**Suncor Energy Cedar Point Wind
Project - Renewable Energy
Approval Amendment
Modification Report**

File No. 160960709

May 2014

Title
Natural Features- T23- Alternative Access Road and Collector Route

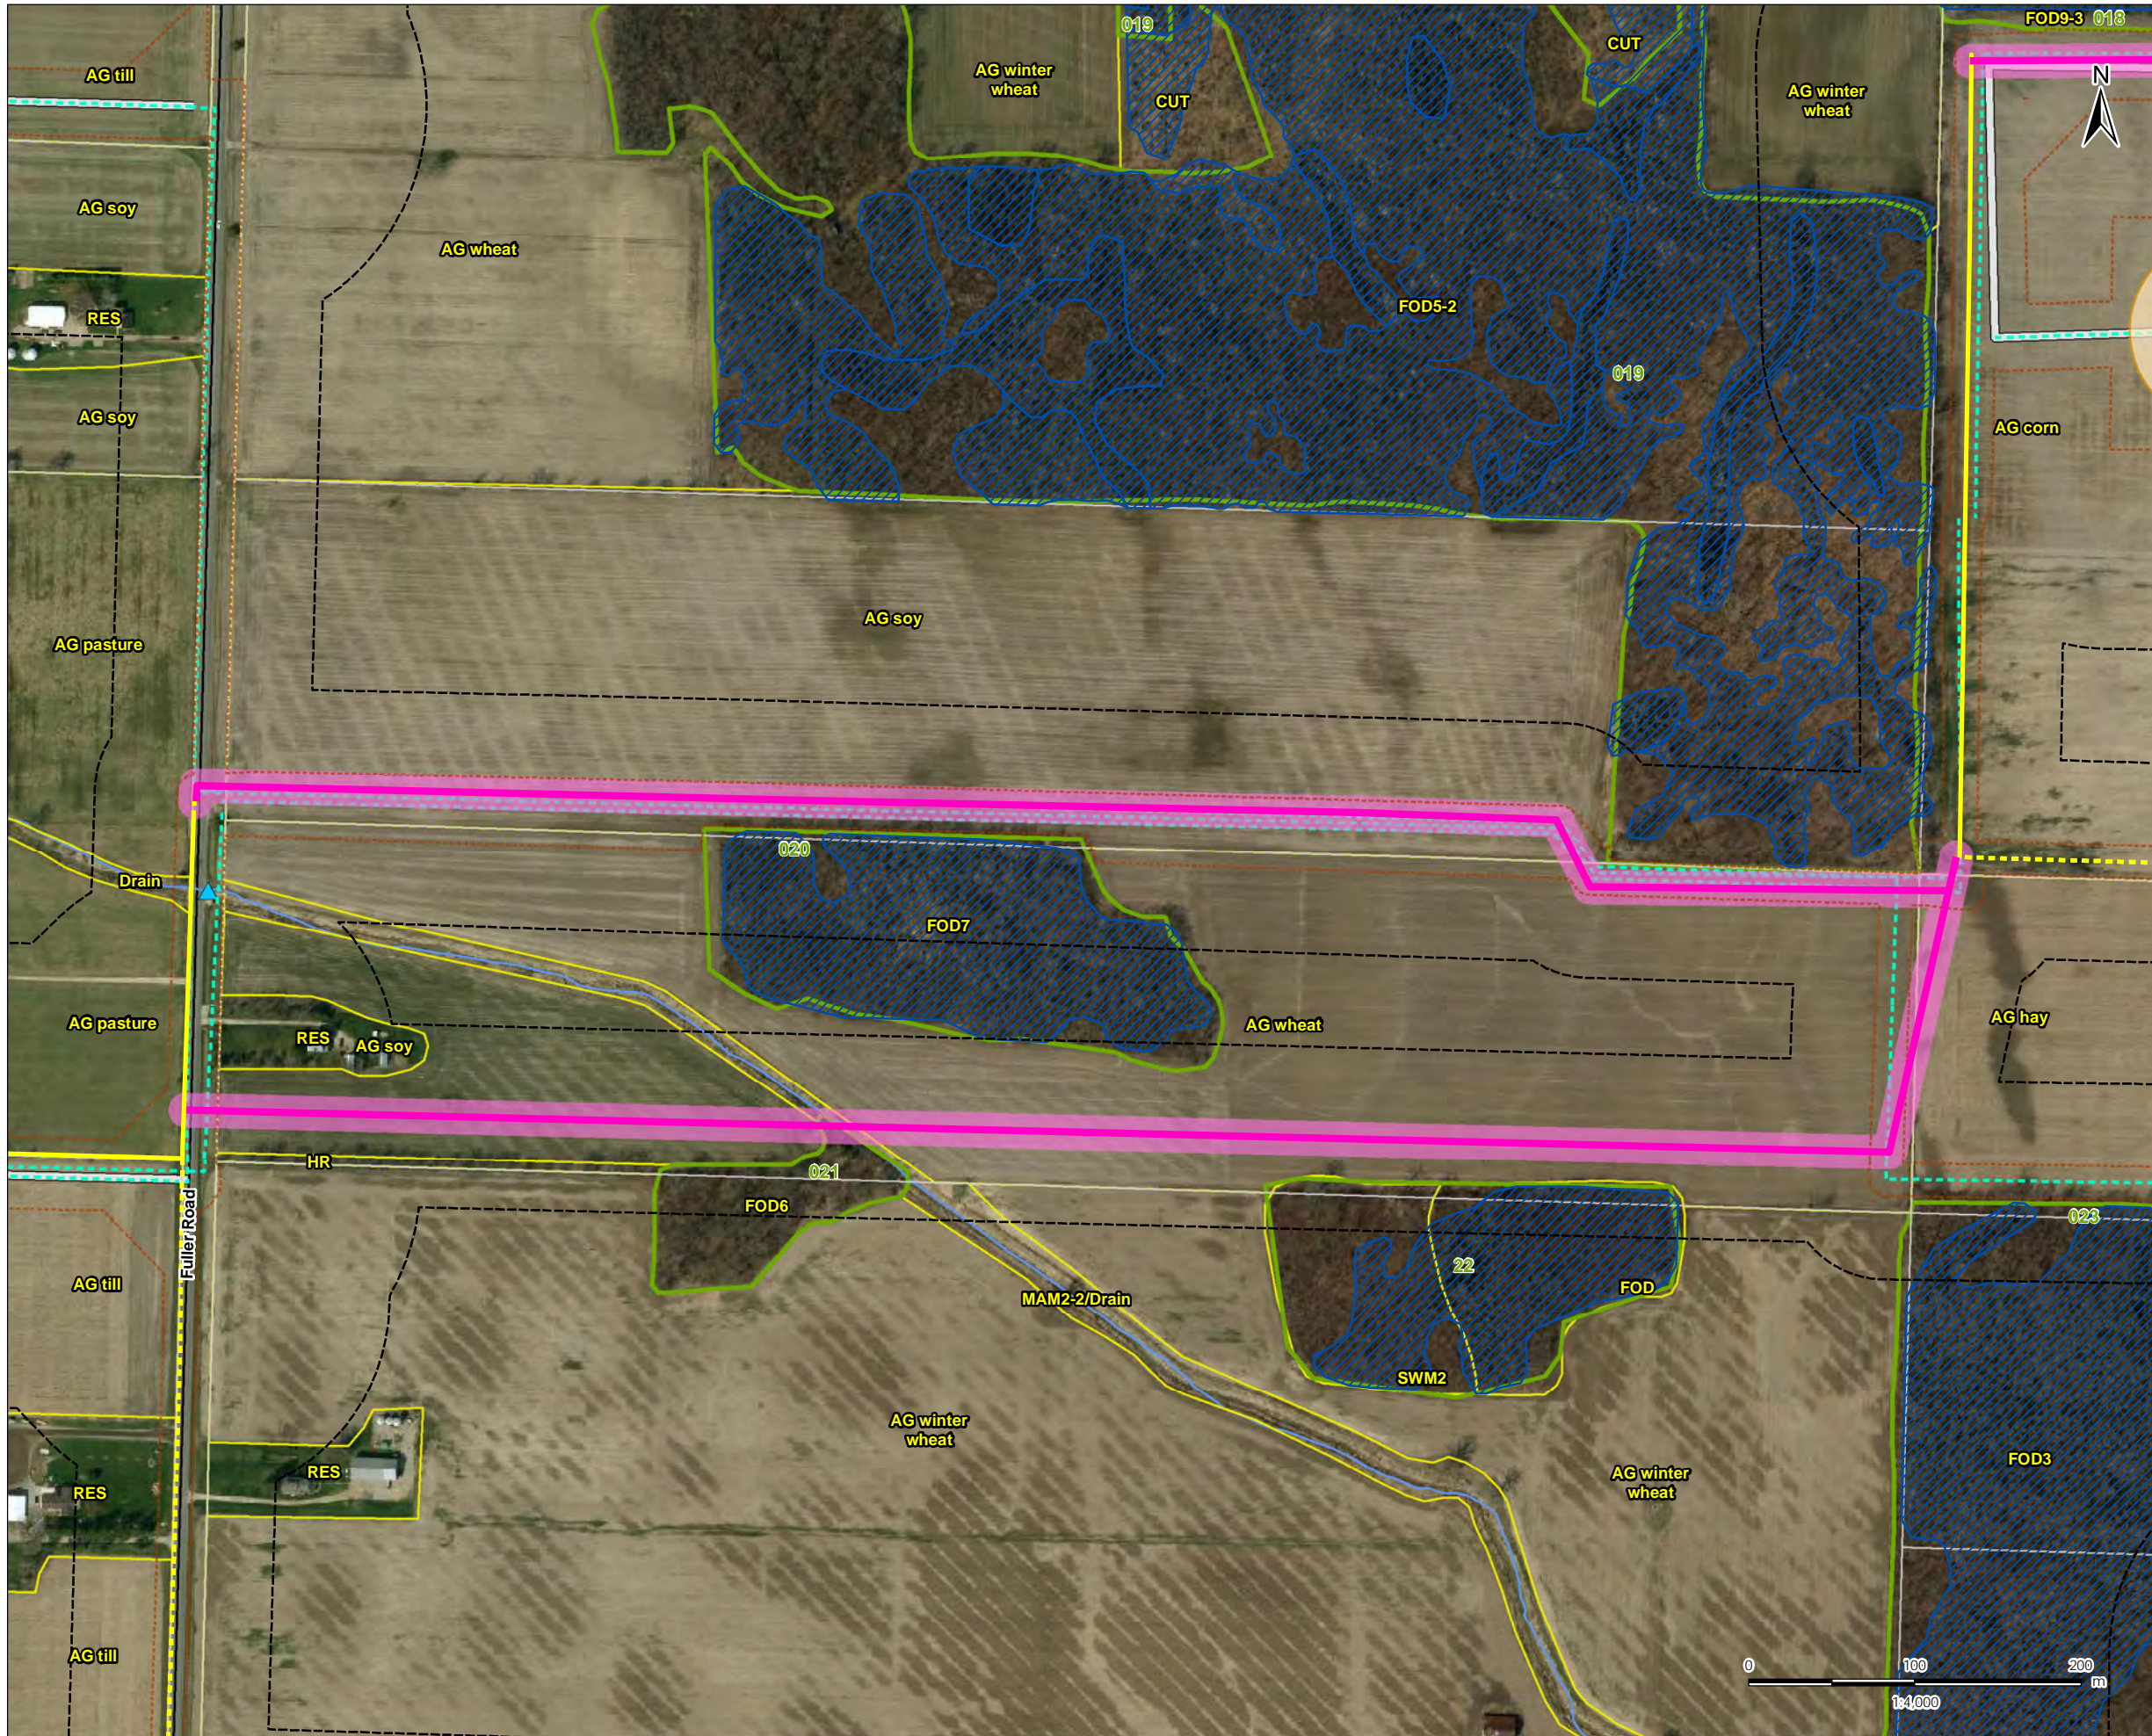
Project Modification 7 moves the location of the access road and underground collector line to Turbine 23 approximately 90 m to the southwest. Moving this access road and underground collector line moves this location further from woodland and wetland Feature 31/31a. **Appendix A, Figure 7** shows the location of the modified underground collector line and access road to Turbine 23. The move is being made by Suncor to address a request made by the participating landowner.

Title
Natural Features – Proposed Transmission Line

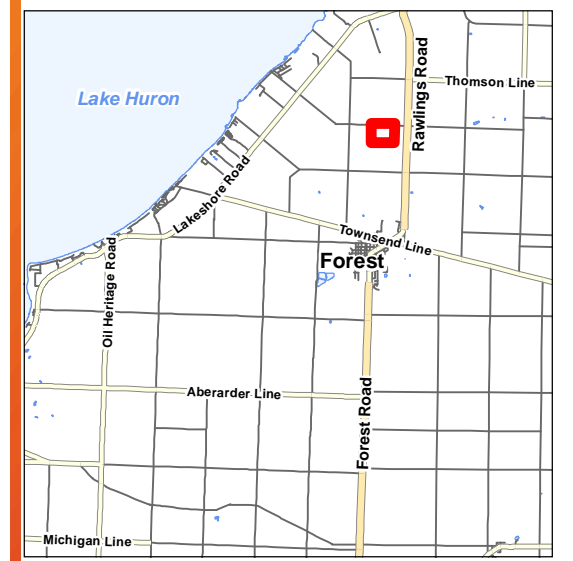
Changes to the location of the overhead transmission line route have been made in the northeast section of the Project. **Appendix A, Figures 8, 9 and 10** show the location of the modified transmission line route. The modification involves a minor shift in the location of the preferred transmission line route and the minor addition of an optional preferred transmission line route in order to avoid Project infrastructure from being located within recently evaluated Provincially Significant Wetland (PSW). Note that only one of the amended transmission line routes will be constructed to avoid Natural Feature 20 as shown in **Appendix A, Figure 8**.

One new feature will be located within 50 m of the new transmission line route running east from Fuller Rd. This feature was originally identified as part of the Cedar Point NHA/EIS site investigations but was removed at a later date due to project layout changes. The feature is shown in **Appendix A, Figure 8** as new Feature 21.

Title
Natural Features – Proposed Collector Line - T71 to Townsend Line along Douglas Line and Uttoxeter Road

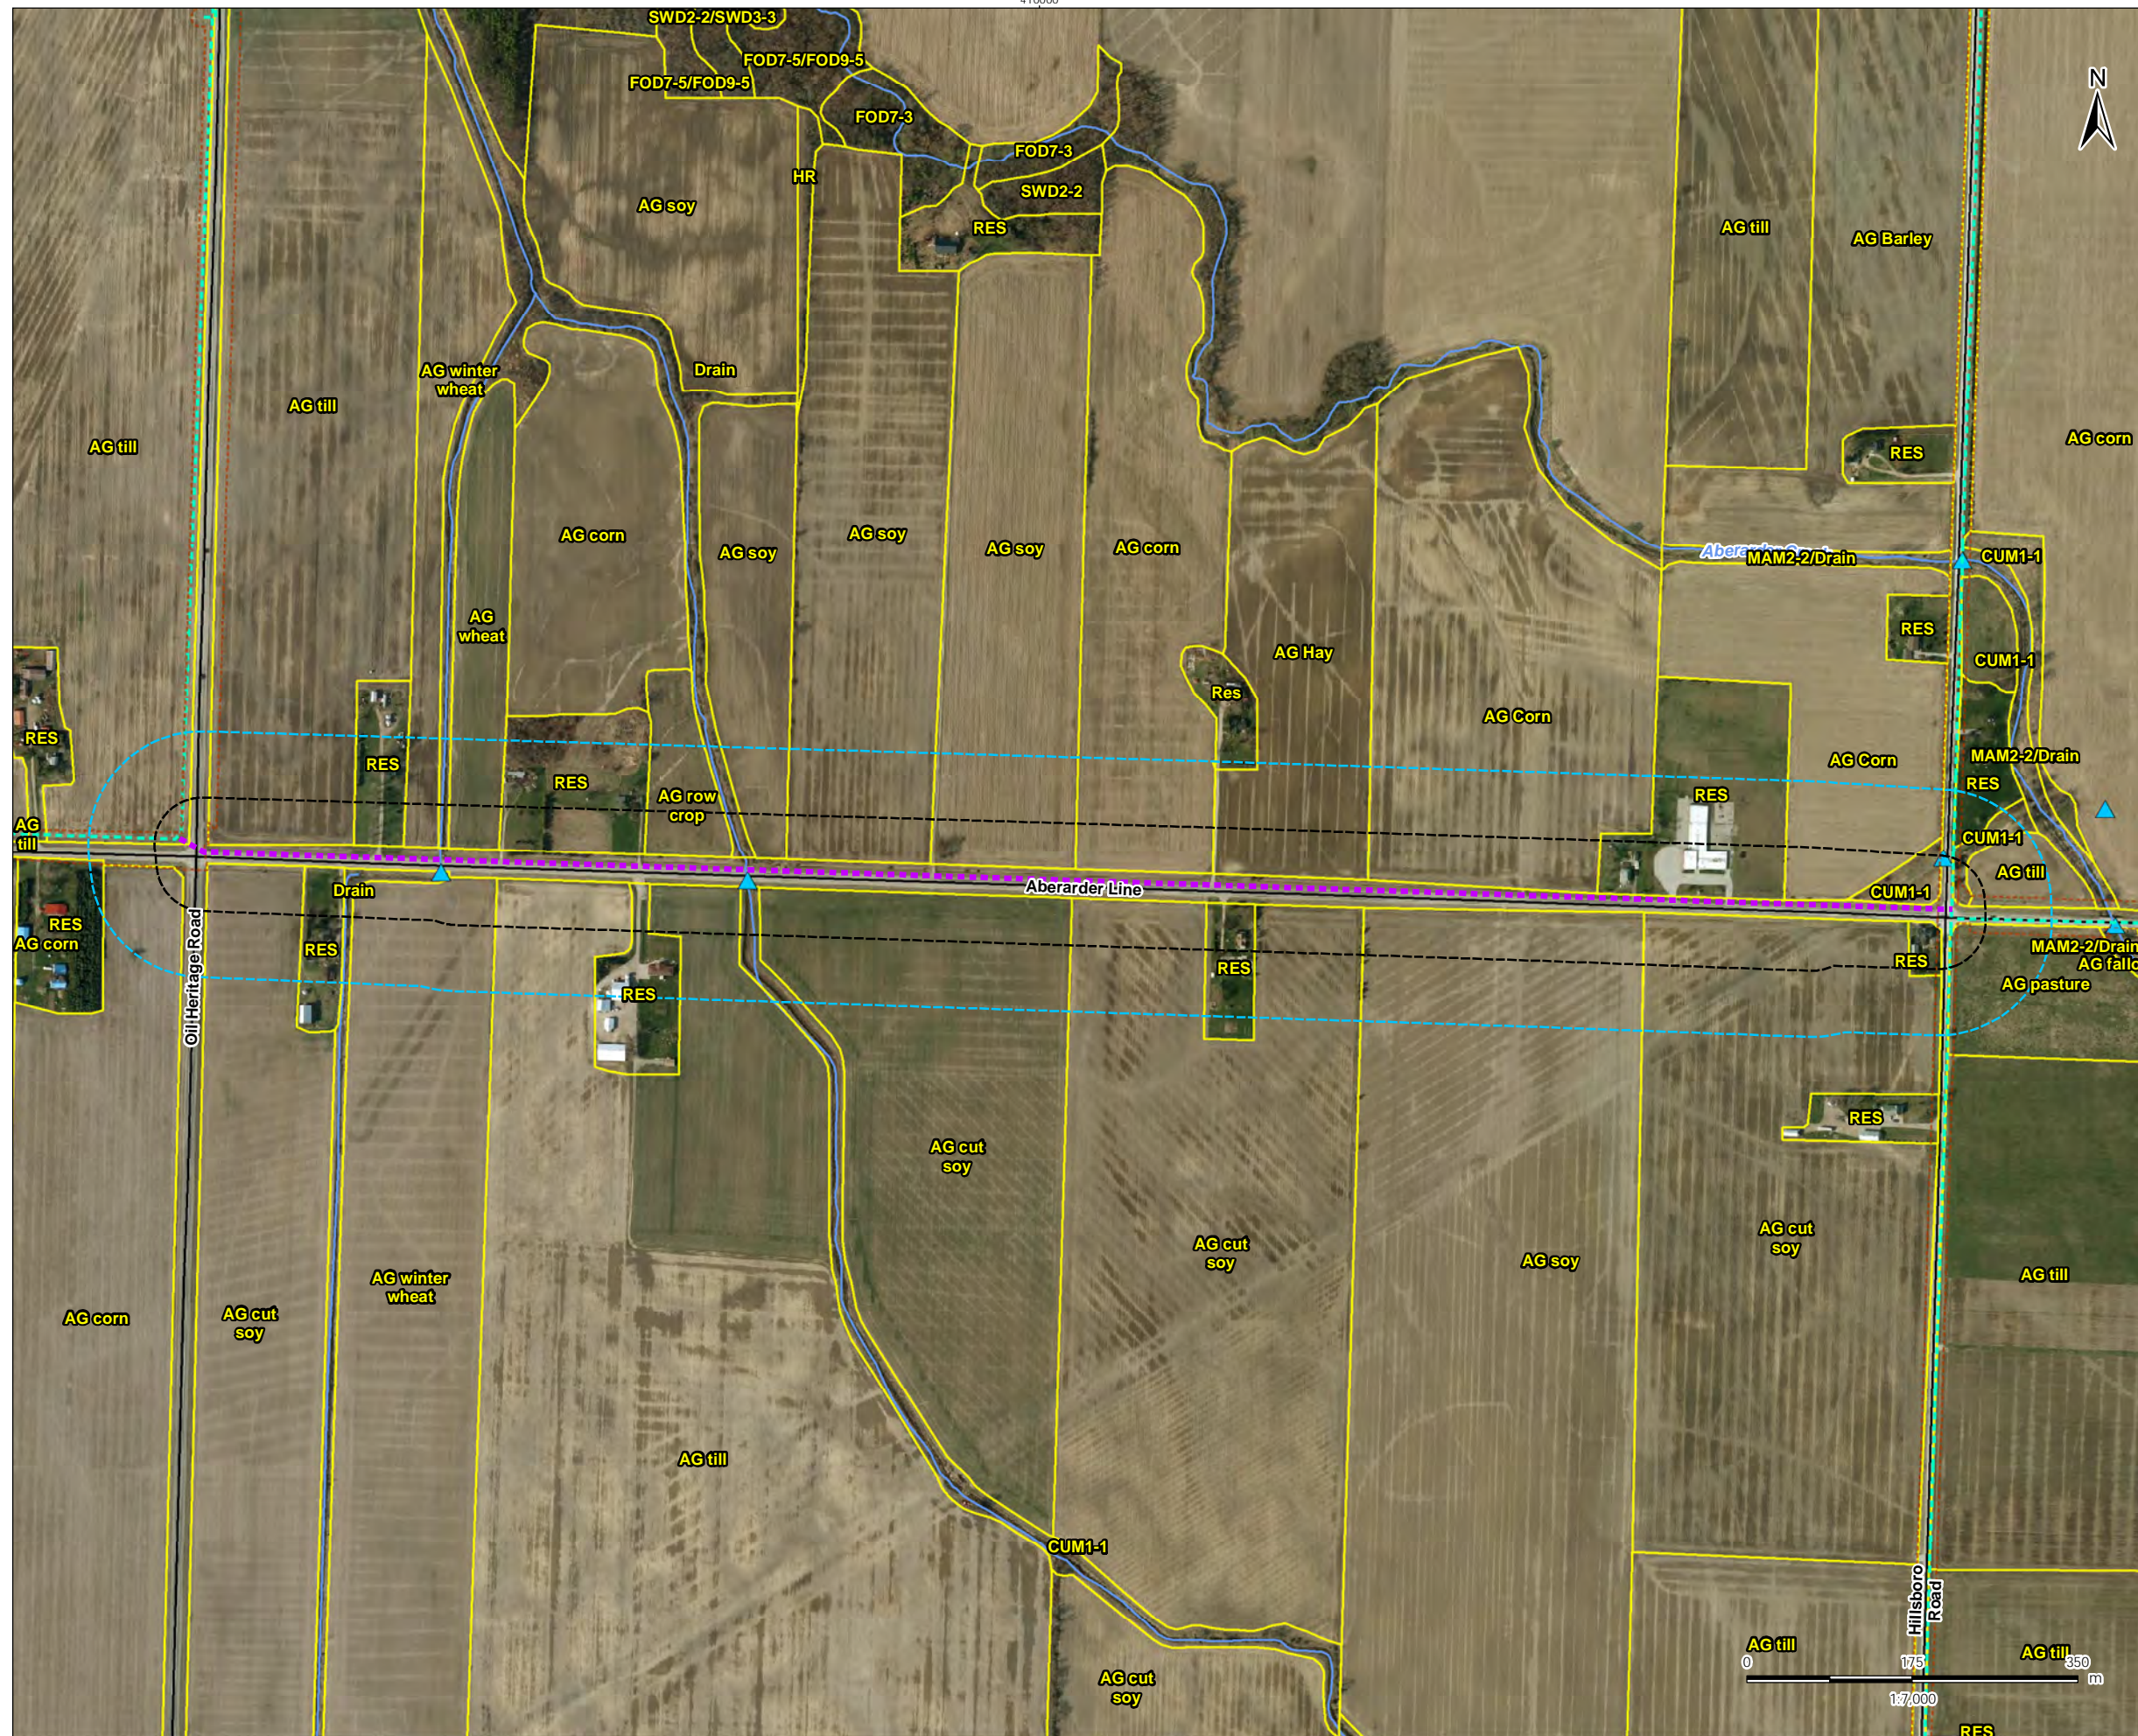
Project Modification 1 involves the addition of an underground collector line along Douglas Line and Uttoxeter Road entirely within the road right-of-way, from T71 to Townsend Line. Figure 1 shows the location of the modified underground cable location. The addition of the underground collector line route provides Suncor with greater design flexibility and minimizes pinch points with respect to connecting Project turbines with the substation.

One new woodland feature was located within 50 m of the new underground collector line running along Uttoxeter Road. This feature was not identified in the April 2013 NHA/EIS. It is shown on Figure 1 as new Feature 78. A site investigation of this feature was completed on March 25, 2014. It contains a dry-fresh sugar maple deciduous forest (Ecological Land Classification code FOD5). No candidate wildlife habitat was identified in this feature. This small (0.98 ha) feature is located 29 m from Feature 45 (the woodland to the west of Feature 78) and so is not considered part of the same feature.
